CONTRACT CHANGE ORDER NO. ____
SHEET ____ OF ____

SAN FRANCISCO OAKLAND BAY BRIDGE
EAST SPAN SEISMIC SAFETY PROJECT

SKYWAY CLEANUP ITEMS
MODIFIED BIKEPATH RAILING DETAILS NO. 1

SHEET
747S2SRI

SECTION AT SLIDING POST
1:1.5

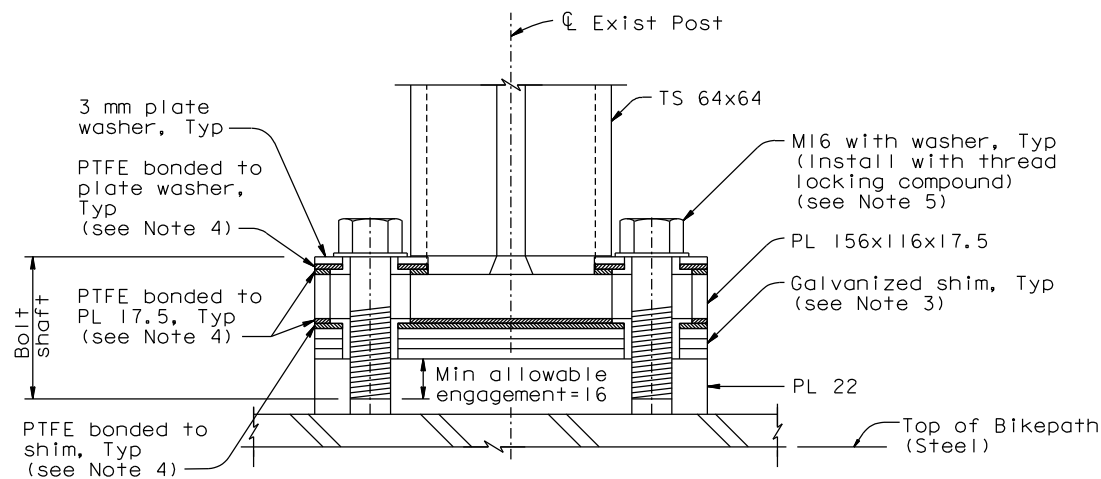
MARK	DATE	DESCRIPTIONS	BY	CH'D	CCO#
12/16/11	12/16/11	SKYWAY DIVIDER RAIL MODIFICATIONS	R. Iliya	JD	219
11/04/11	11/04/11	SKYWAY DIVIDER RAIL MODIFICATIONS	A. Baumberger	JD	219

1. Install sliding post with the bolts centered in the slots. Use sliding plate washer.
2. Install standard/conduit post.
3. If the bolt in the standard/conduit post is located in the center or to the inside (toward the post) of the slot, then use the inner plate washer.
4. If the bolt in the standard/conduit post is located in the center or to the outside (away from the post) of the slot, then use the outer plate washer.

2. Sliding post shall be installed with the bolts centered in the slots (± 3 mm).
3. The Contractor may use shims as necessary to align top rail of bikepath railing. One shim may be tapered.
